**Engineering Classrooms and Offices in 61  
NAU Project #09.610.173  
March 19, 2020**

**ADDENDUM #2**

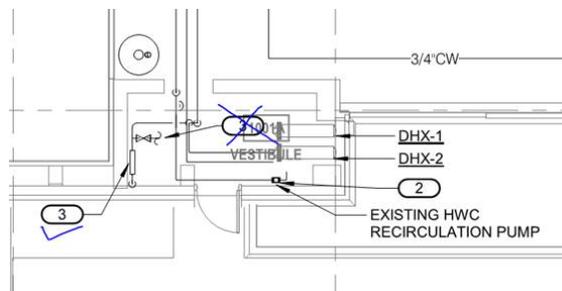
- A. **Question:** Sheet P103.1 has two key notes #3 pointing to different items, please clarify.

*Answer: Delete the uppermost keynote.*

1. Sheet P103.1 – refer to Clarification A.

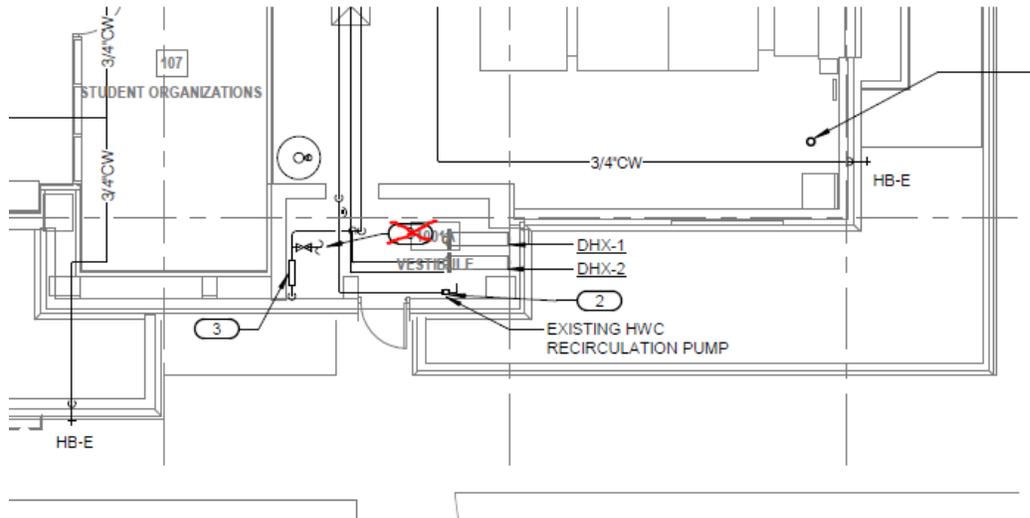
DELETE: Where there are two Keynote #3s delete the uppermost one as shown in the drawing below:
